# Justification for Class 3 Permit Modification, Corrective Action Complete with Controls, Solid Waste Management Unit 76, Mixed Waste Landfill, Sandia National Laboratories/New Mexico, EPA ID Number NM5890110518 Volumes I through VIII

**Justification for Class 3 Permit Modification  
Corrective Action Complete with Controls  
Solid Waste Management Unit 76  
Mixed Waste Landfill**

**Volume I of VIII  
Class 3 Permit Modification for Corrective Measures,  
Final Order, and Corrective Measures  
Implementation Plan**

**Figure 1. Trigger evaluation process for the Mixed Waste Landfill (revised)**

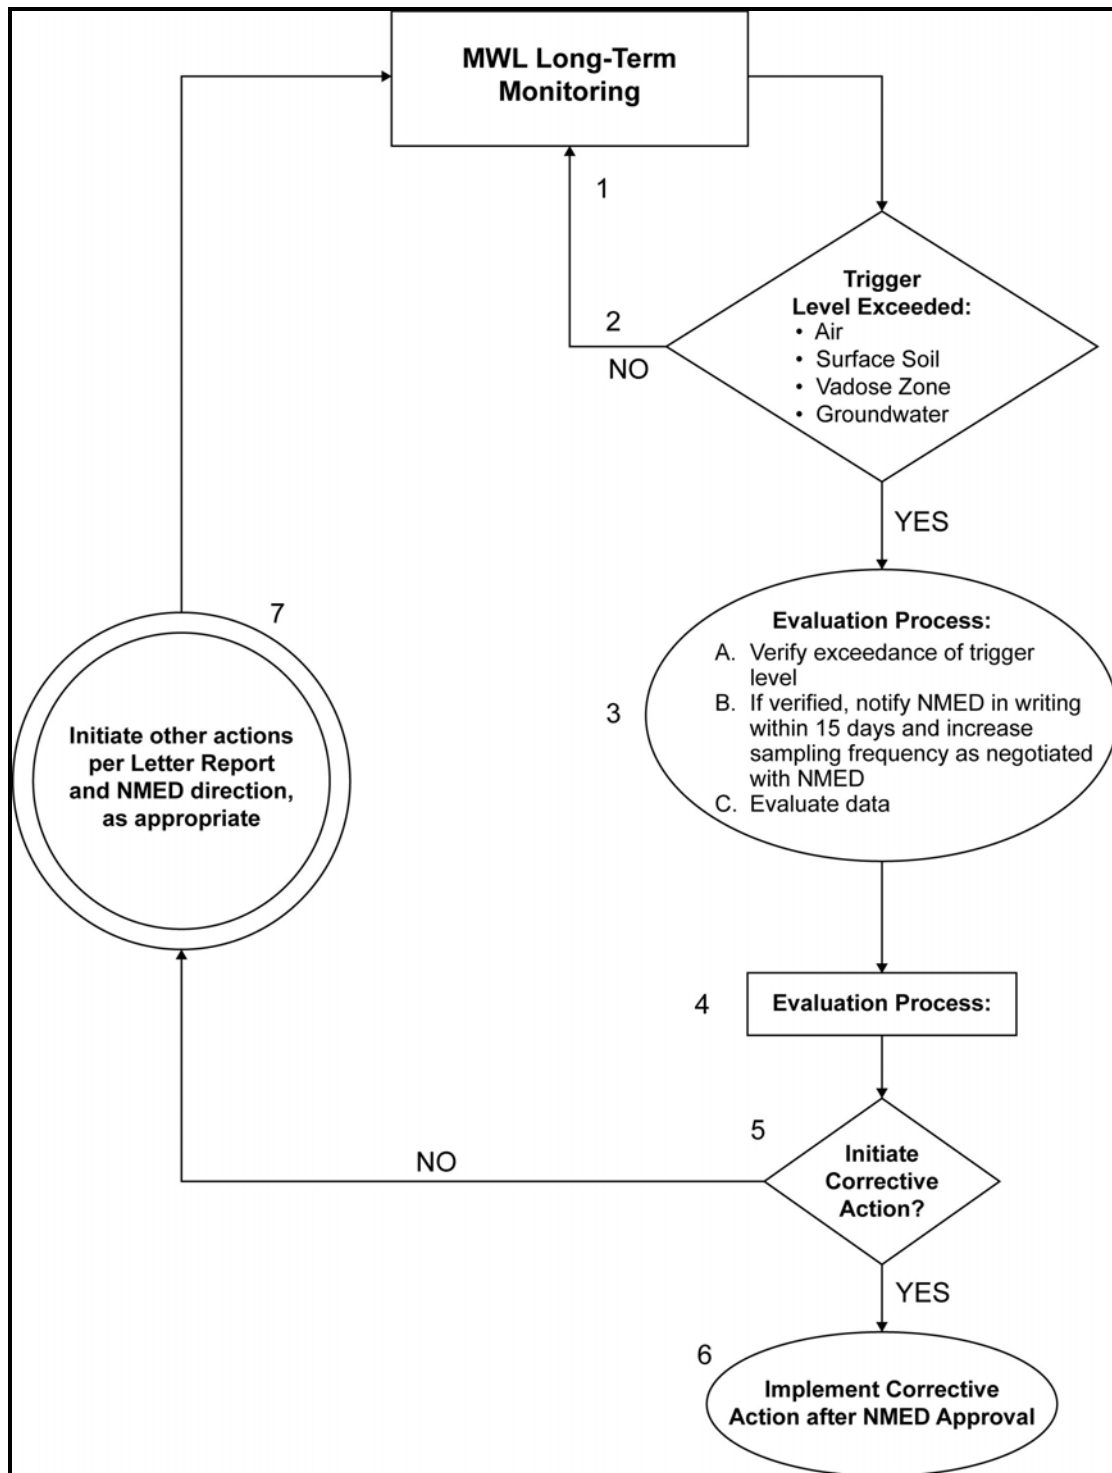
**7. Section 3.3 -- The fourth paragraph of Section 3.3 discusses the dose via inhalation and dermal adsorption for gas-phase tritium, but a similar discussion is not presented for radon gas or gas-phase PCE. Clarify whether this dose discussion is applicable to all gas-phase constituents considered in the Report. If the dose discussion is only applicable to gas-phase tritium, then explain why this is the case. Alternatively, discuss inhalation and dermal adsorption doses for radon gas and gas-phase PCE.**

**Response:** Inhalation and dermal adsorption of gas-phase radon and PCE were not used as performance metrics in this analysis. Table 1 in Section 3.1 of the Performance Assessment Modeling Report summarizes the performance metrics that were used for these constituents. Text has been added to clarify this in the report. The inhalation dose is only applicable to gas-phase tritium because the enforceable regulatory metrics pertaining to radon and PCE do not use dose (surface flux is used for radon and groundwater concentration is used for PCE).
